COUNTY OF VENTURA PUBLIC WORKS AGENCY WATERSHED PROTECTION DISTRICT ZONE 2 "J" STREET DRAIN IMPROVEMENT ORMOND BEACH LAGOON TO DOWNSTREAM OF HUENEME ROAD IN THE CITY OF OXNARD

SAVE DATE: 5/21/13 DOKTORN K:\PC\PROJECTS\82322 J STREET DRAIN IMPROVEMENT\FINAL DESIGN\DESIGN DRAWINGS\100%ADDENDA\ADDENDUM NO. 1\JSD-01-GP.DWG

"J" STREET DRAIN IMPROVEMENT
ORMOND BEACH LAGOON TO
DOWNSTREAM OF HUENEME ROAD
GENERAL PLAN

PRIVATE CROSSING PLAN

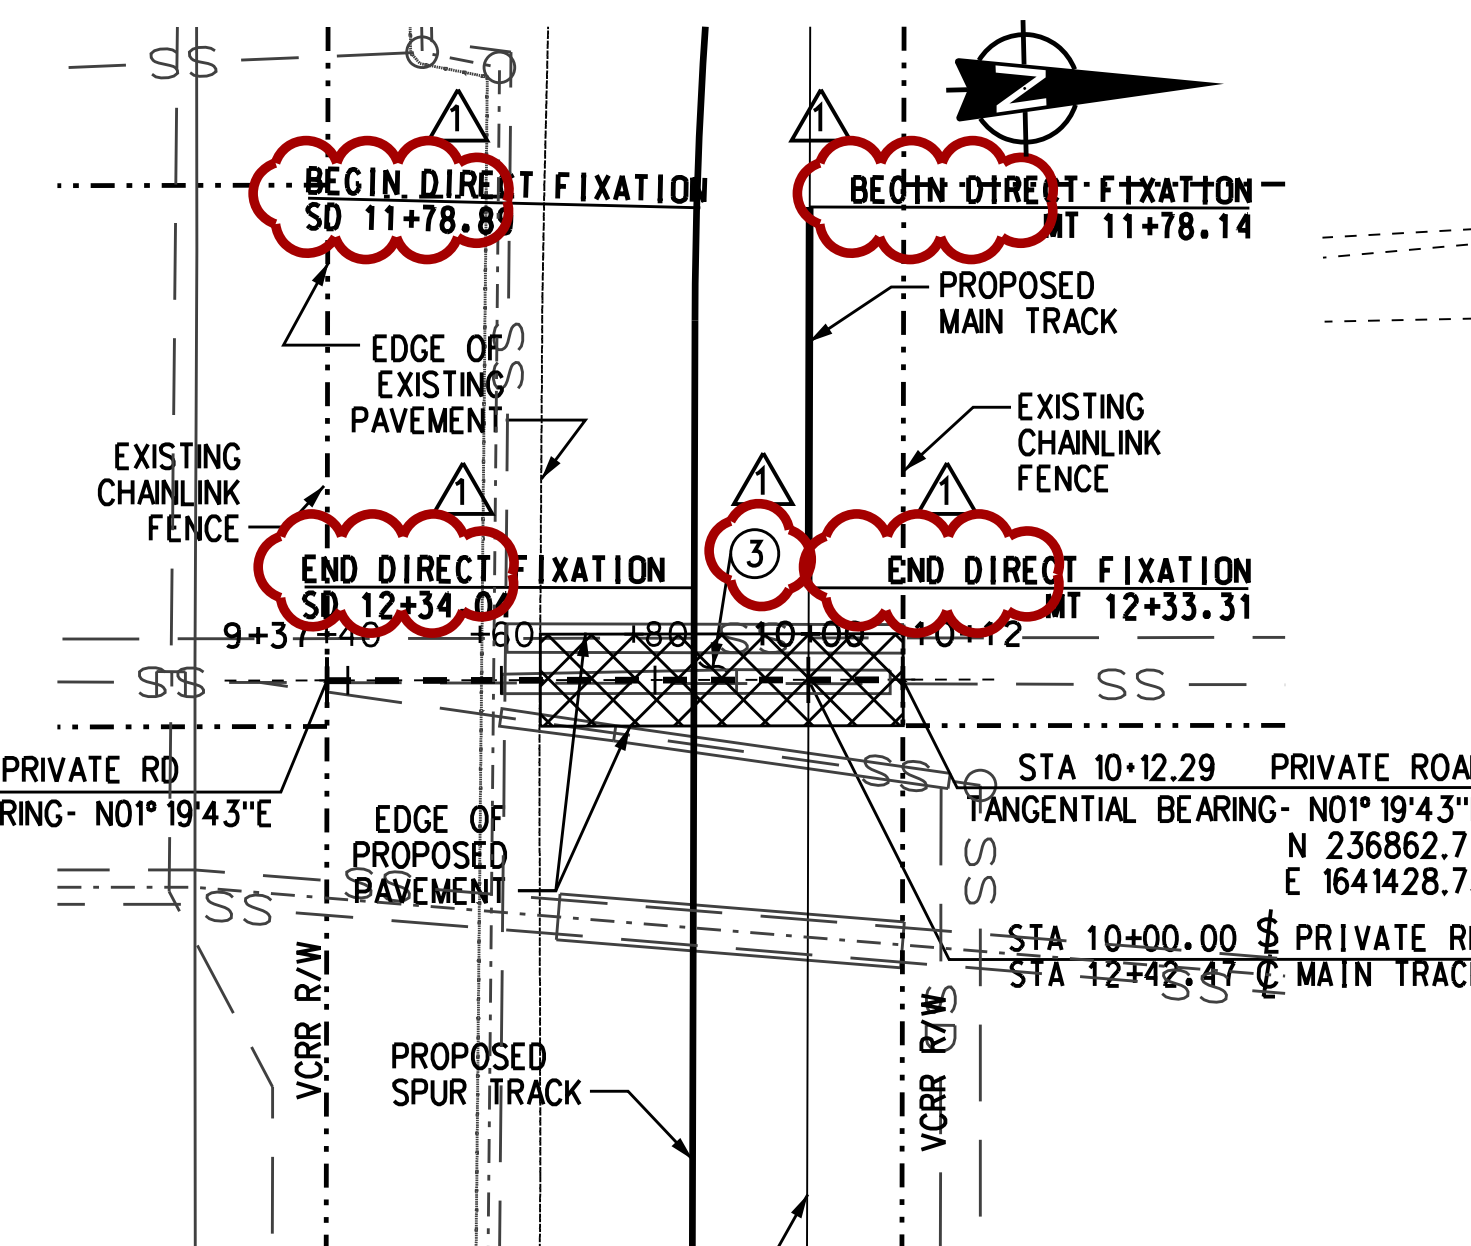
D					
C					
B					
Δ	REVISE DETAIL AND CALL OUTS	EML	06/21/13	APPROVED:	DATE
Δ	REVISION DESCRIPTION	APP.	DATE	PORT OF HUENEME, OXNARD HARBOR DISTRICT

SHEET 7C	OF 31
DRAWING NO. Y-2-3711C

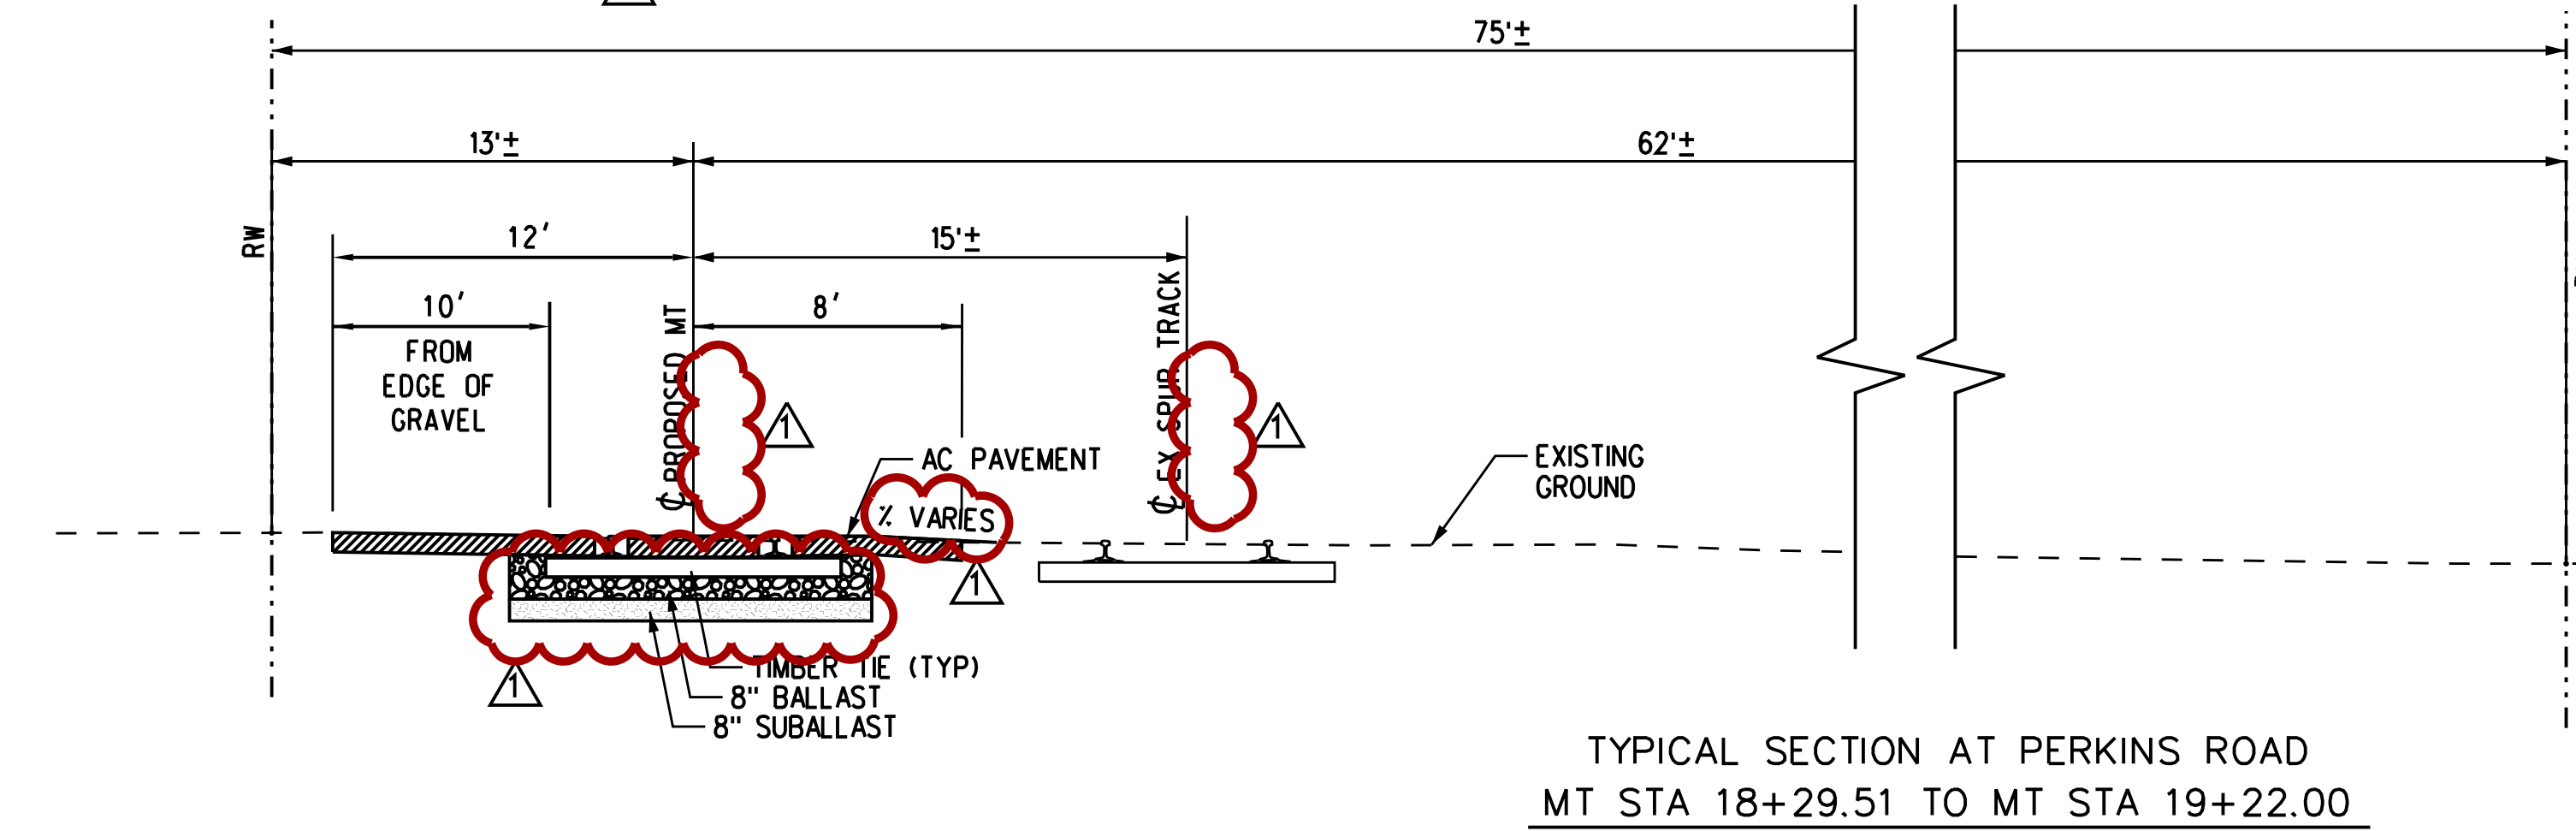
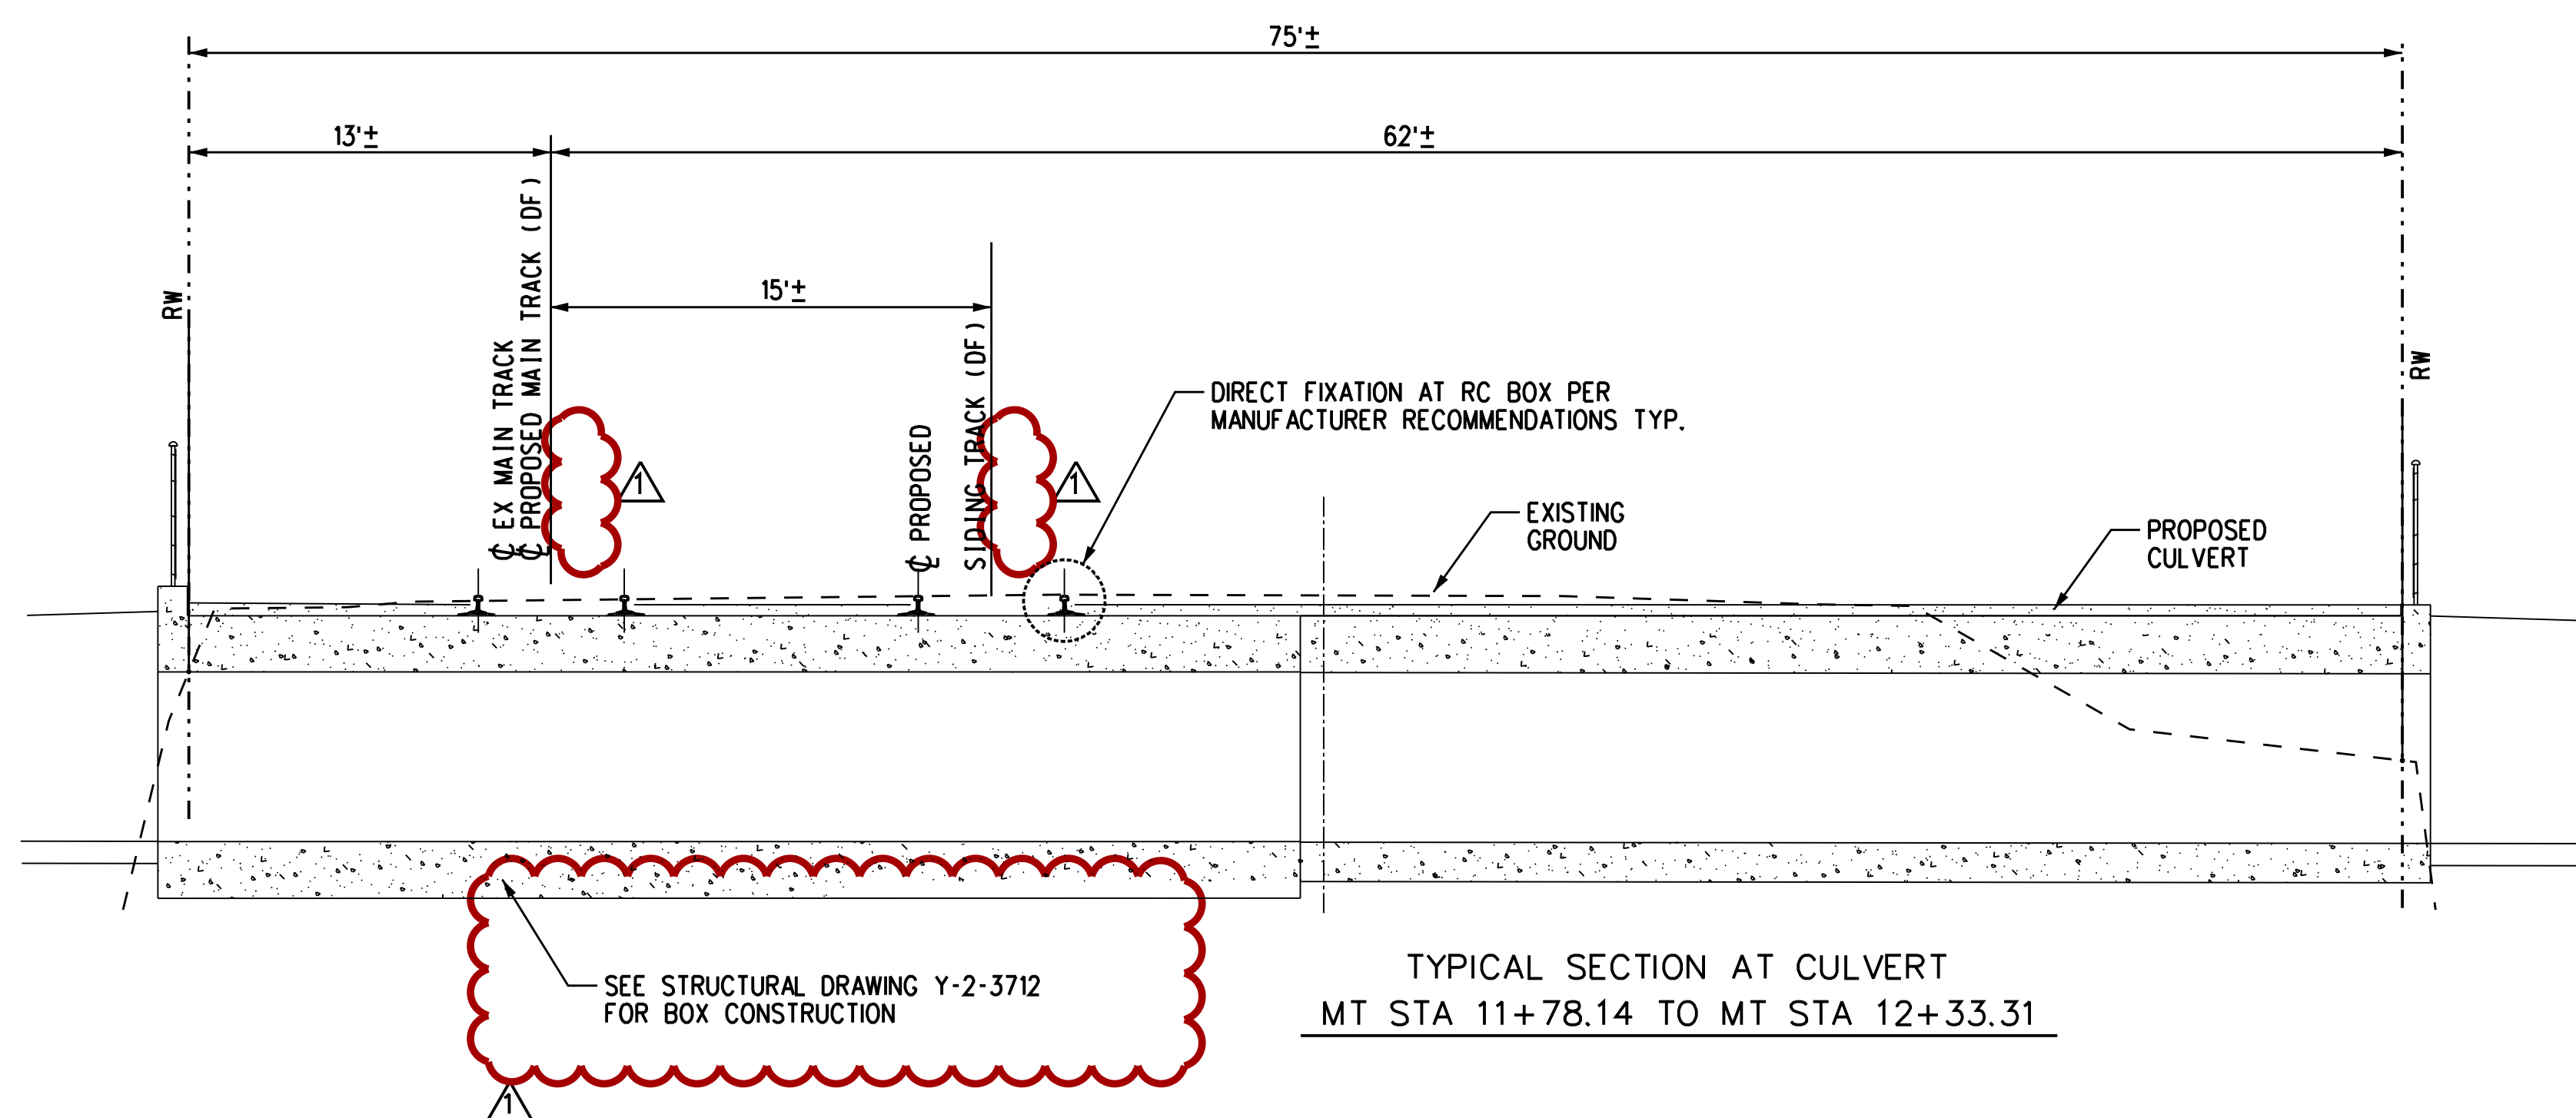
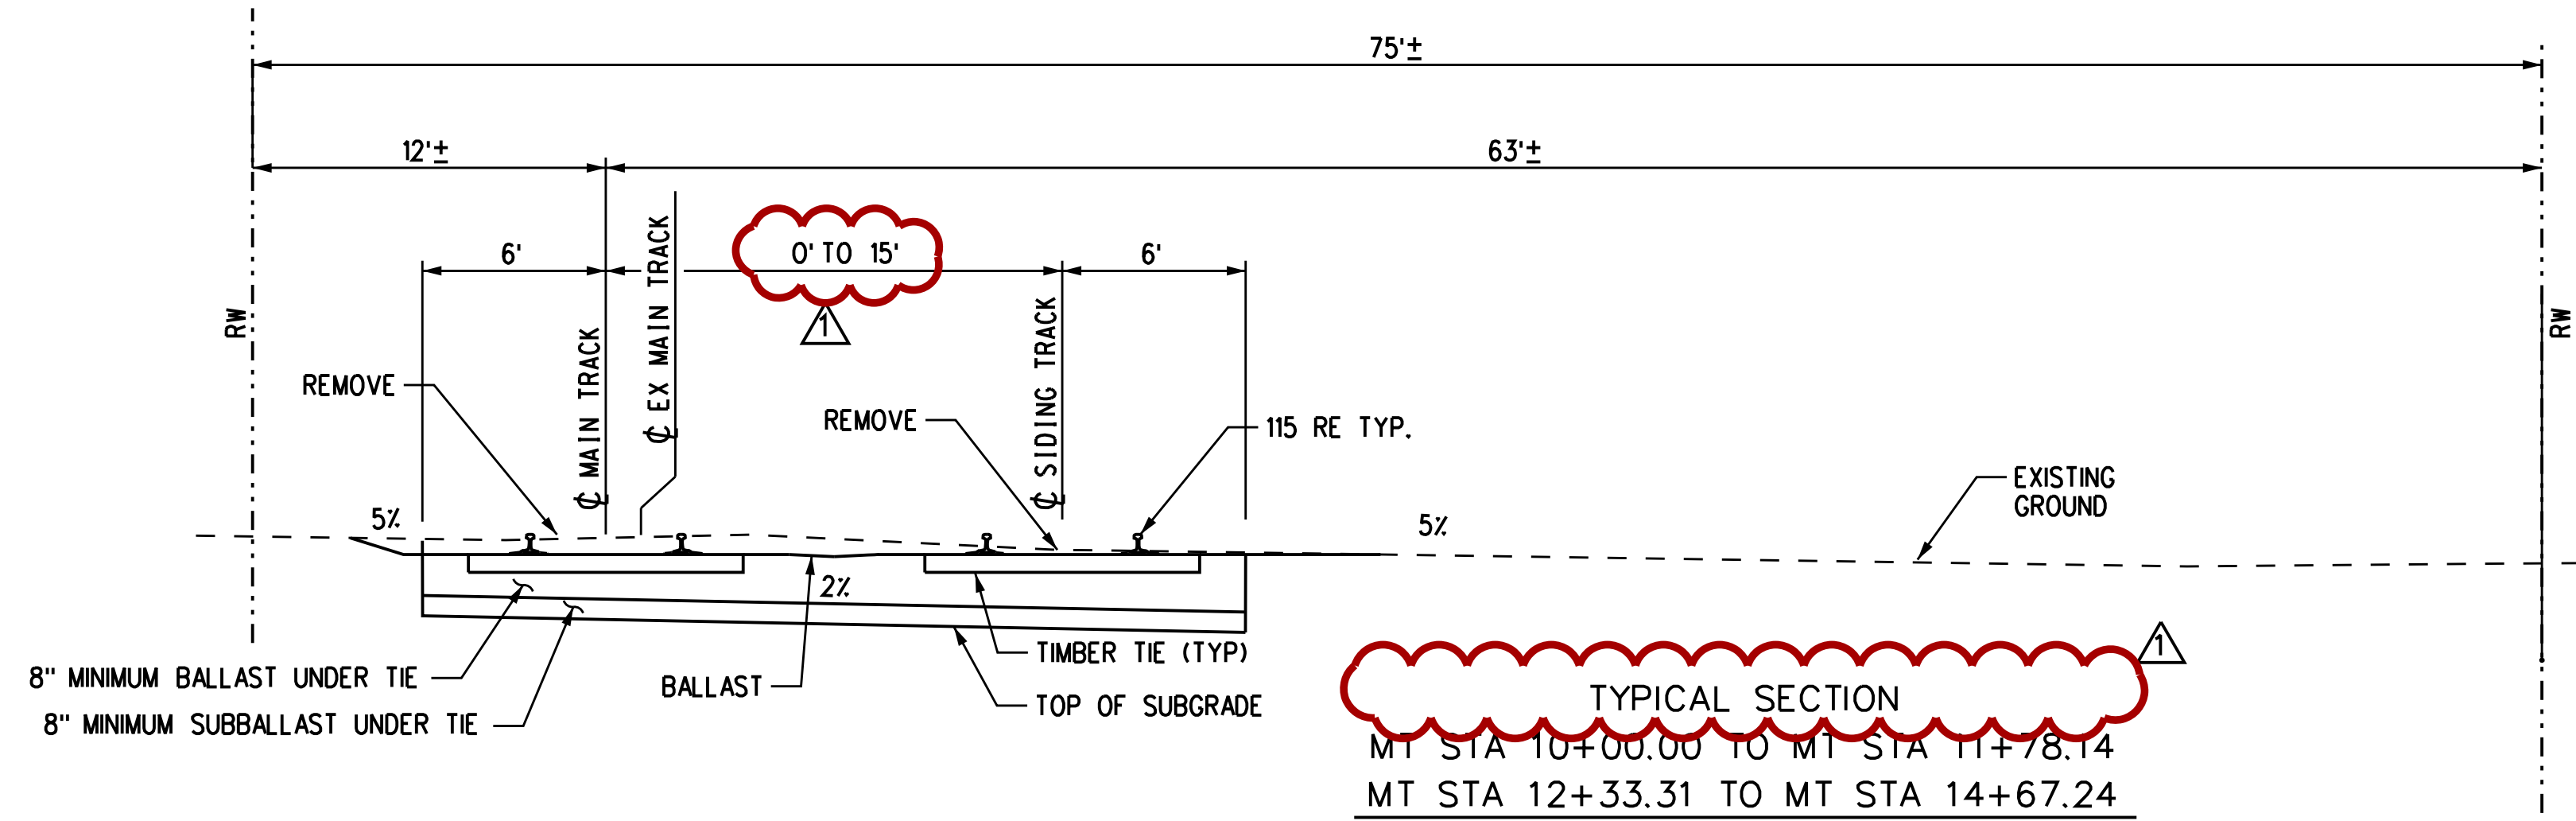
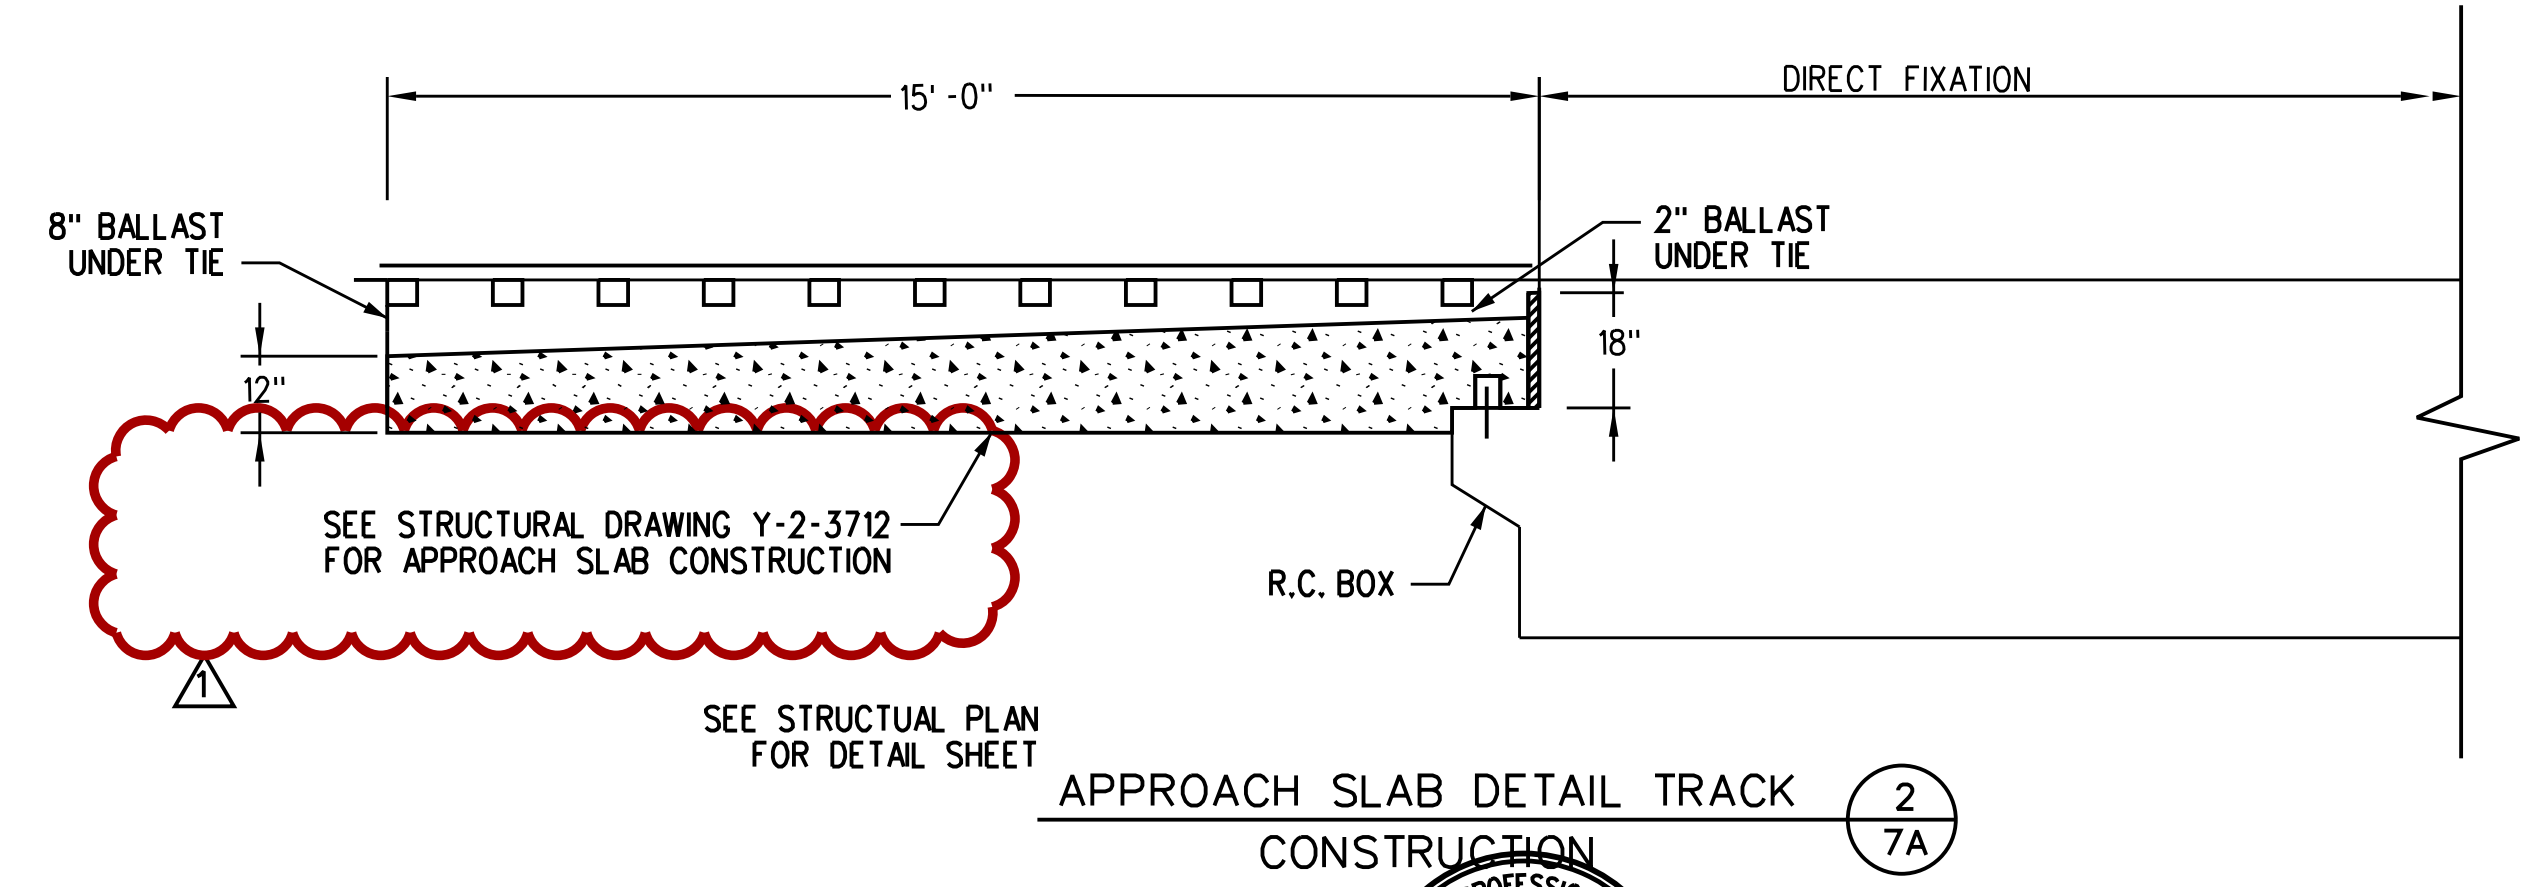
REVISION	DESCRIPTION	APP.	DATE
1	REVISE DETAILS AND CROSS SECTIONS	EML	06/21/13
